ZONING PLAN

Canton Road Commercial
Land Lot 588, 16th District, 2nd Section
Cobb County, Georgia

PETITION NO: Z-1

PLANNING COMMENTS:

Z-1
Sheet

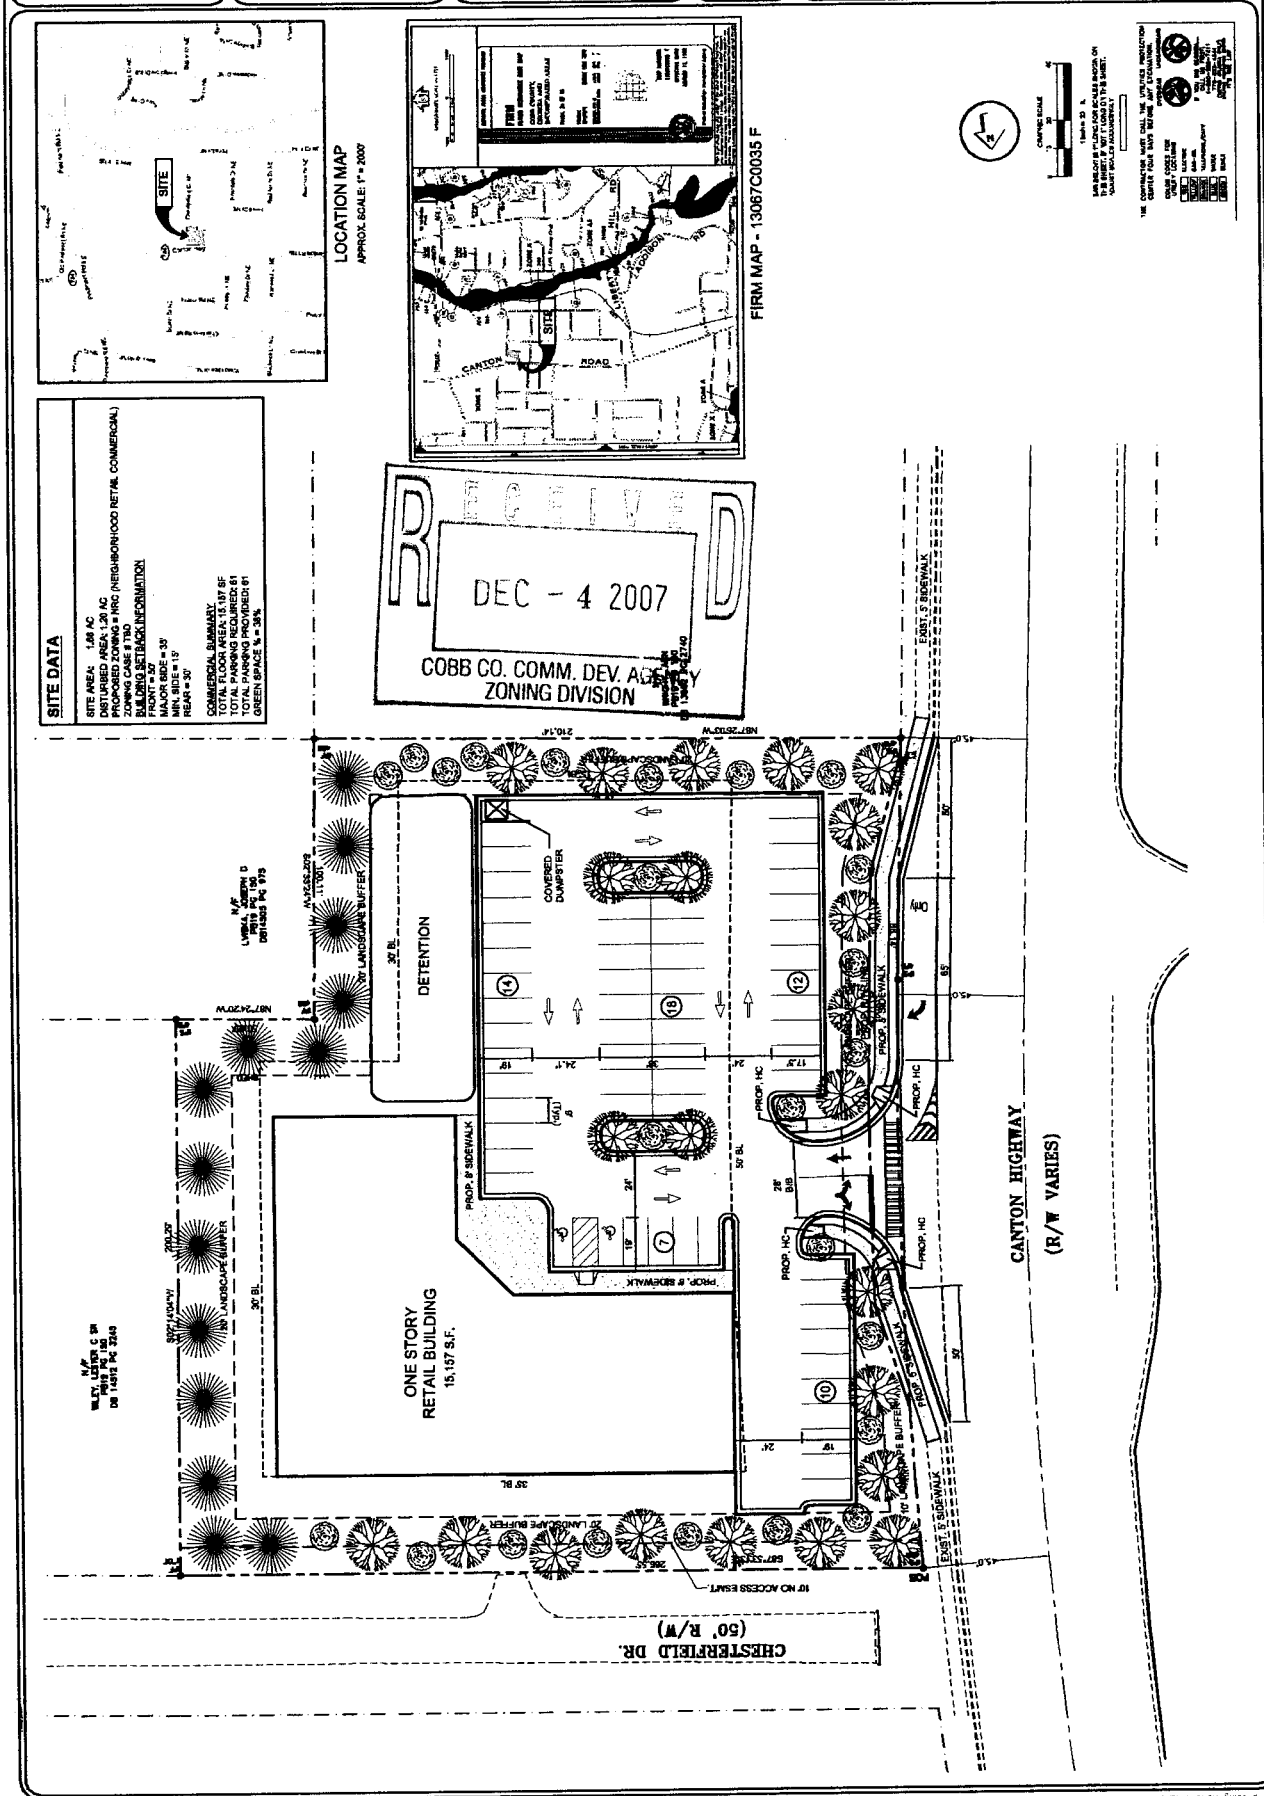
Notes FYI: *Dumpster site should be closer to building so that drain can more easily be connected to sewer as required in code*

1. This site slopes to the southeast. The existing natural drainage discharges via sheet flow through adjacent residential lots to Jewell Drive. A new house is currently under construction just downstream of this site. Since there is no defined downstream conveyance for the proposed detention facility a drainage easement will be required to provide for a concentrated site discharge through the downstream parcel(s) to the Jewell Drive R/W – preferably to tie directly into the existing Jewell Drive culvert.

2. The proposed commercial development will result in a significant increase in runoff volume over the existing conditions. Due to the limited existing downstream system capacity and several previous downstream drainage complaints elevated detention will be required such that each design storm discharge is controlled not to exceed the allowable discharge of the next lower, more frequent storm event (ie. 5-year storm event released at 2-year rate; 10-year event at 5-year rate; etc. to 100-year event at 50-year rate).

No access to Chesterfield Drive.

As necessitated by this development for egress from Canton Road, a deceleration lane will be required.

- Site plan received by the Zoning Division December 4, 2007, with the District Commissioner approving minor modifications;
- District Commissioner approve building architecture and signage;
- No access to Chesterfield Drive;
- 20-foot buffer adjacent to all residentially zoned property;
- No lighting that would glare onto the adjacent residential property;
- Letter from Mr. Garvis L. Sams, Jr., dated January 15, 2008 (not in conflict with these stipulations);
- Fire Department comments;
- Water and Sewer comments and recommendations;
- Stormwater Management comments and recommendations;
- DOT comments and recommendations;
- owner/developer to enter into a Development Agreement pursuant to O.C.G.A. §36-71-13 for dedication of system improvements to mitigate traffic concerns.
